PREPARED FOR THE PLAN COMMISSION AND URBAN DESIGN COMMISSION

Project Address: 4103-4119 Portage Road (17th Aldermanic District, Alder Clausius)
Application Type: Rezoning, Demolition, and Conditional Use
Legistar File ID #: [37648](#), [37370](#)
Prepared By: Heather Stouder, AICP, Planning Division
Report Includes Comments from other City Agencies, as noted

Requested Action: Approval of a rezoning from Temporary Agriculture to the Suburban Residential – Varied 2 (SR-V2) district, demolition of a single-family home, and a conditional use for a 284-unit multi-family residential complex.

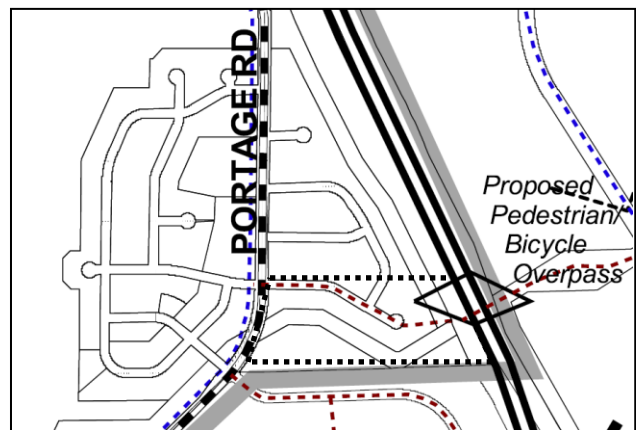
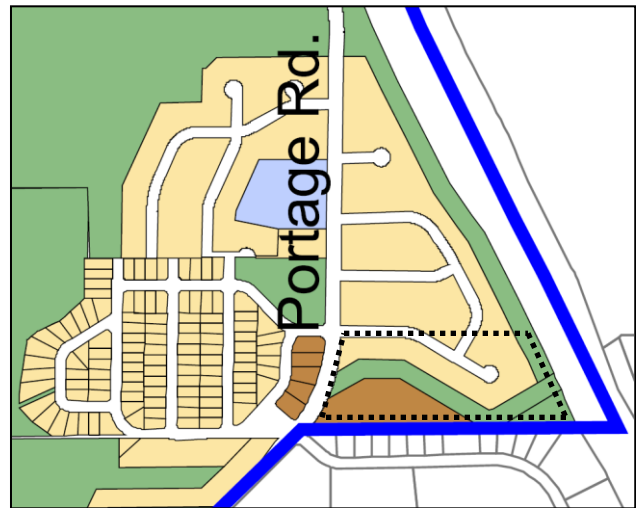
The Hanson Road Neighborhood Development Plan (last adopted in 2000) recommends Low-Density Residential (defined differently in this Plan as <8 dwelling units per acre) uses for portions of this property north of the creek, and medium density residential uses (defined in the Plan as 12-16 dwelling units per acre) for a small portion of the subject property south of the creek. On average, the subject site is recommended for approximately 10-12 dwelling units per acre. (See the subject property within the dashed line on the map excerpt at right.)

The Hanson Road NDP also recommends a bicycle/pedestrian overpass to link this property to the American Center, over I-39 (see map excerpt at right). Recently, staff has been made aware that this connection would more than likely be a tunnel under the interstate done in conjunction with a major WisDOT project. While not programmed at this time, staff anticipates that it could occur within the next 15 years. The applicant has agreed to provide an easement for this planned connection as part of the CSM associated with this request.
